FIRE SAFETY REPORT

6 CHAIR DENTAL FACILITY HENDERSON INTERMEDIATE

JN 206281

We have reviewed the proposed new dental 6 Chair Facility at Henderson Primary, based on the drawing supplied by Kay & Keys Architects. We consider the drawing complies with the fire safety provisions of the NZBC, subject to the following:

Dwg #	FSK 05	Drawn	SDW
Revision	1	Verified	PM
Date	15 Apr 2010	Approved

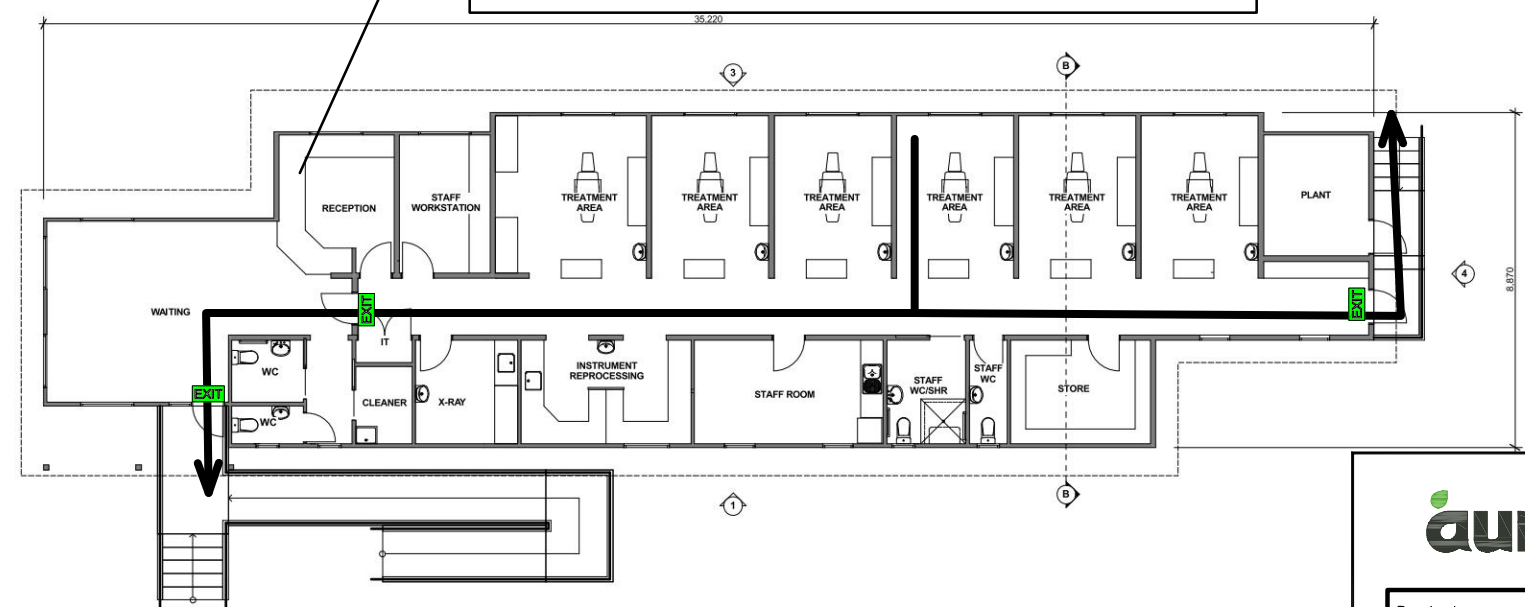
Refer to C/AS1 3.4 'Length of escape routes' and Table 3.3. The allowable dead end open path (DEOP) and total open path (TOP) lengths are 24 m and 60 m respectively. The maximum DEOP and TOP are within these limits as shown on FSK-05 Therefore the escape route lengths comply with the requirements.

- Located as shown on drawings FSK-05
- Located on a vertical surface within 600 mm of the door
- Worded EXIT or FIRE EXIT plus a directional arrow if necessary
- Height of lettering minimum 50 mm but may be greater depending on viewing distance
- Colour being white on safety green background, except any area usually under dimmed lighting conditions in which case the colour may be safety green on black background
- Sign shall be internally illuminated and comply with F8/AS1 'Signs' and the Standard AS/NZS 2293.3:1995 'Emergency evacuation lighting for buildings – Emergency luminaires and exit signs'

Dead end travel distance = 4 m
Total travel distance = 28 m

Exit sign
locations

Max travel
lengths
